Subject: RESPONSE TO REQUEST FOR ADDITIONAL INFORMATION REGARDING  
APPLICATION FOR REVISION 5 OF THE RH-TRU 72-B SHIPPING  
PACKAGE, DOCKET NO. 71-9212, TAC No. L24419

**Responses to NRC Request for Additional Information (RAI) on Revision 5 of the RH-TRU 72-B Cask Safety Analysis Report (SAR), Revision 1 of the Remote-Handled Transuranic Waste Authorized Methods for Payload Control (RH-TRAMPAC), and Revision 1 of the RH-TRU Payload Appendices**

Figure 1 – Damage Assessment of NS30 #1 Cold Drop Test Article

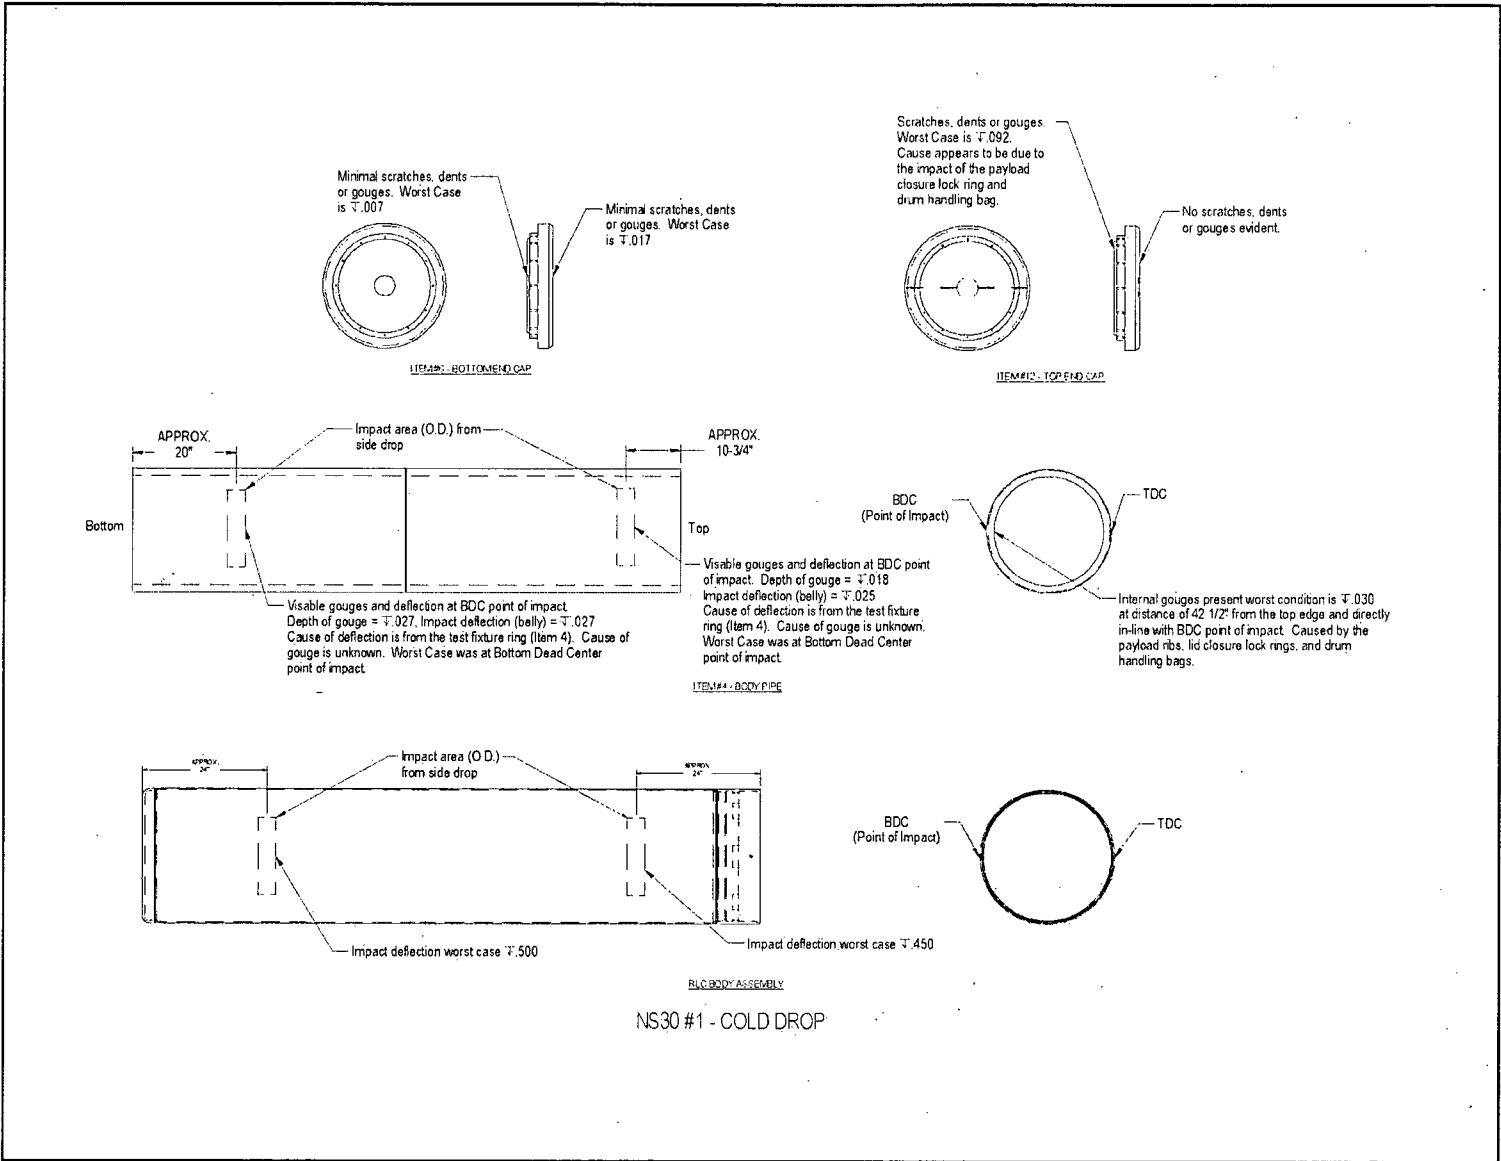
6. Provide a complete stand-alone description of the summary of damage to the various structural components for NS-30 model, under NCT and HAC events.

RH-TRU Payload Appendix 5.1 Sections 5.1.3.2.2 through 5.1.3.2.4 provide a summary description of the damage to the NS30 canister metallic lid and body and shield insert polyethylene top and bottom end caps and pipe body. Additionally, as repeated below in Figure 1 and Figure 2, the Petersen Engineering Report 7953-R-027 provides a detailed summary of maximum damage to these components in Appendices E and H.
